# 3rd & Cherry

DESIGN REVIEW BOARD  
2<sup>nd</sup> RECOMMENDATION MEETING

Project Address: **601 4th Avenue**  
SDCI Project #: **3028747**

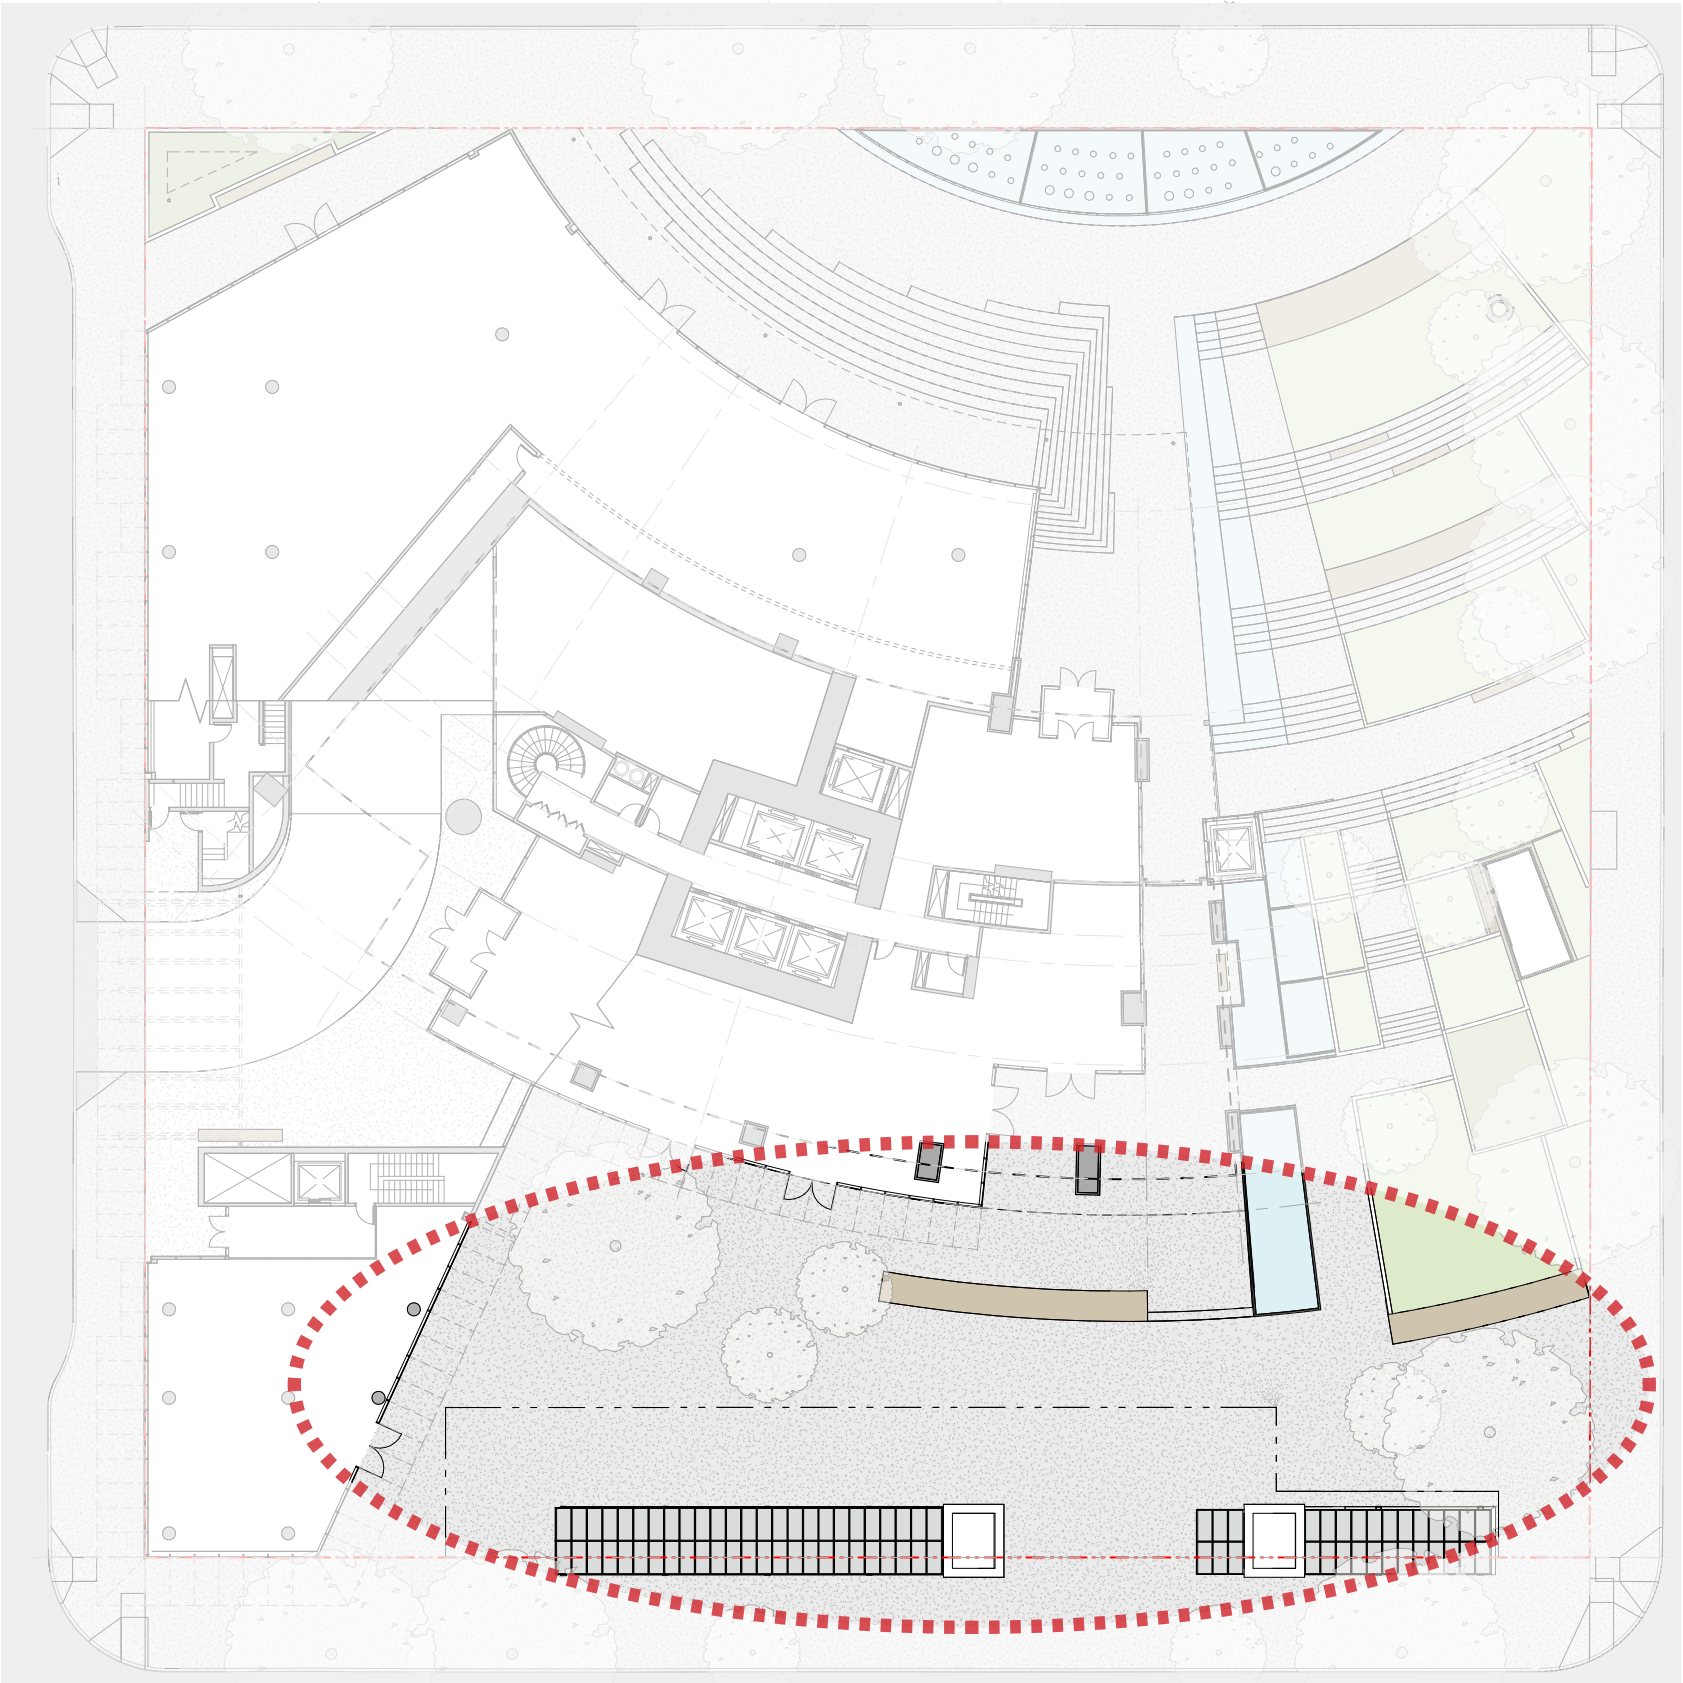
The Board commented that the design of the lower level plaza needs to be very flexible and that they would support a design with more flexibility. They encouraged the design team to work with Sound Transit to understand proposed future improvements to the transit stop and further explore the design of the plaza adjacent to transit stop. (D1)

Trees have been relocated away from the easement to ensure maximum flexibility. Furthermore, the plaza is fully leveled and pavers are extended into the easement to ensure continuity and adjustability of this lower plaza.

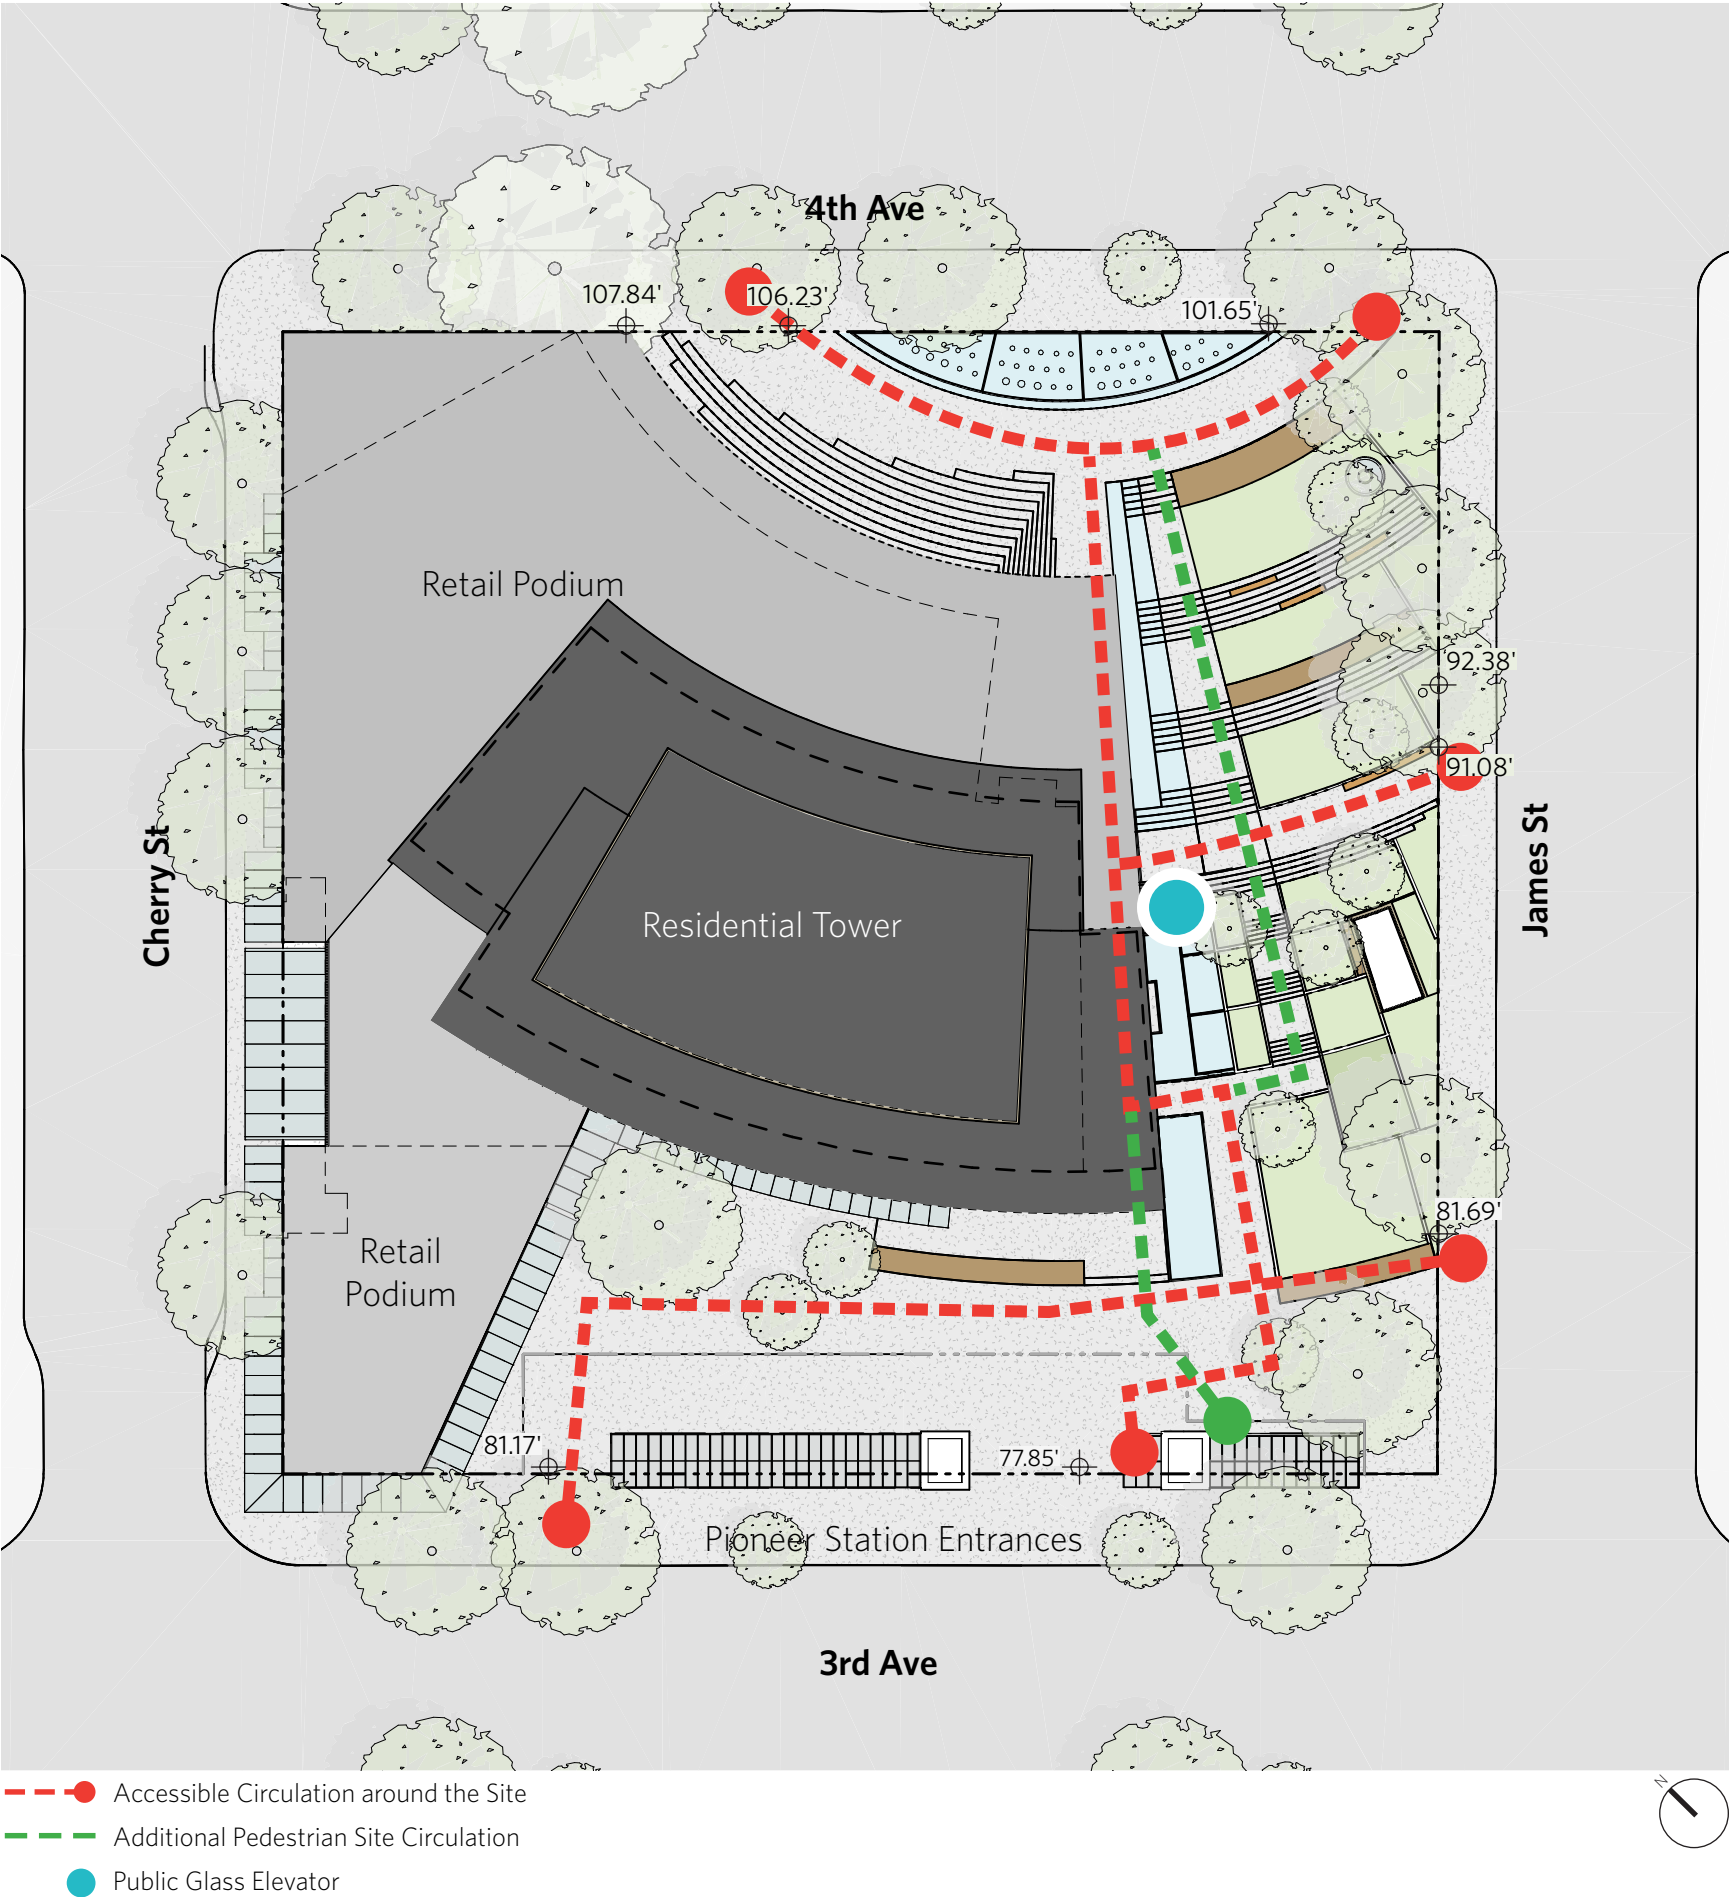
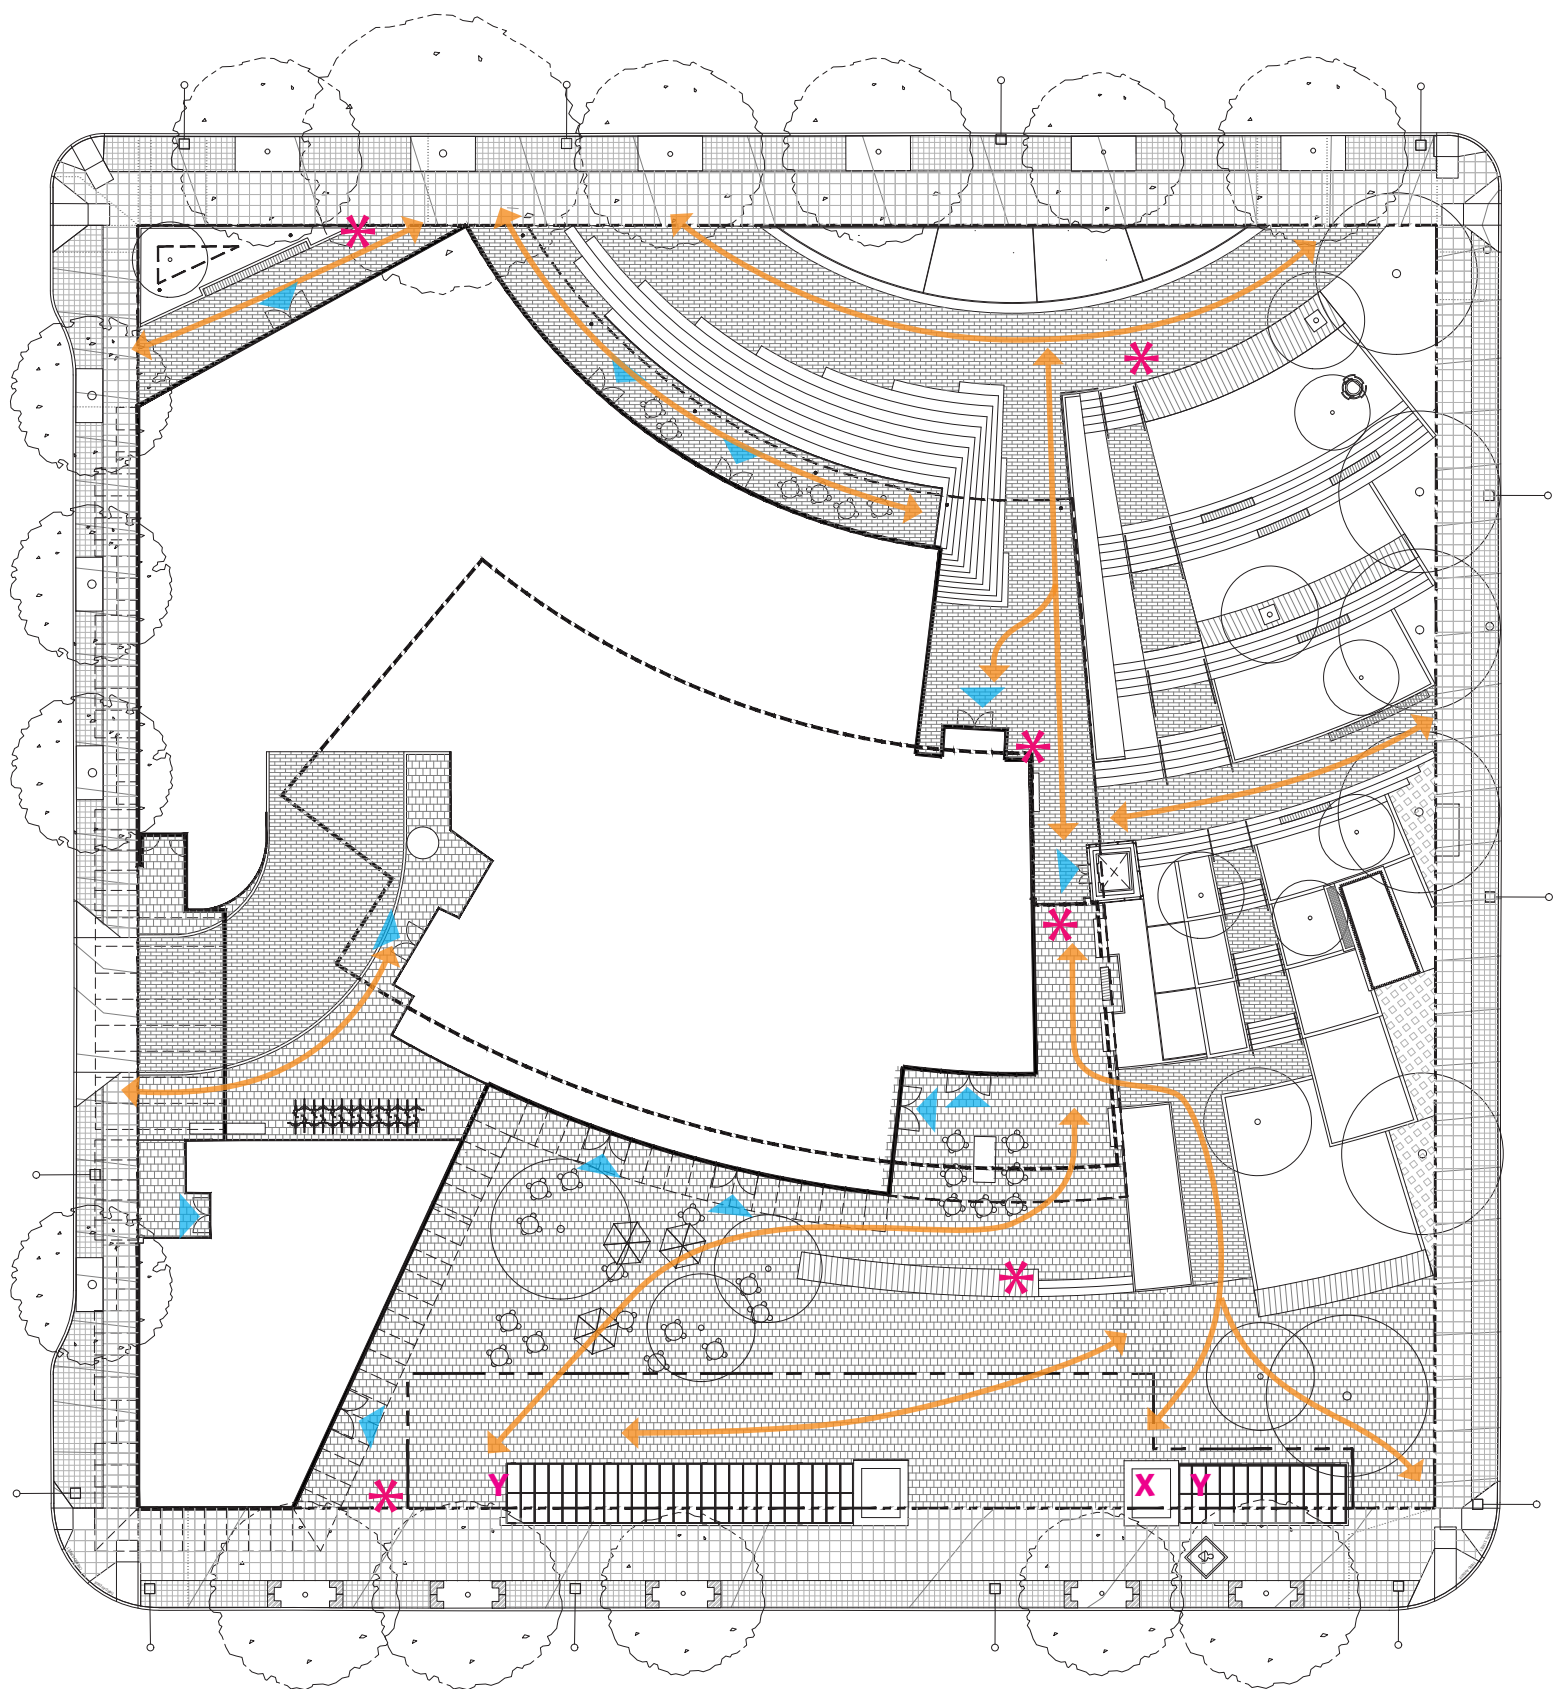
Provide additional clarity of wayfinding to the elevator and show circulation options for users to get to the elevator from various locations on the site. (D1.2.a, D6)

The elevator can be accessed from several locations throughout the site. Circulation as well as proposed wayfinding locations, located at each corner of the site, are shown in the diagram below.
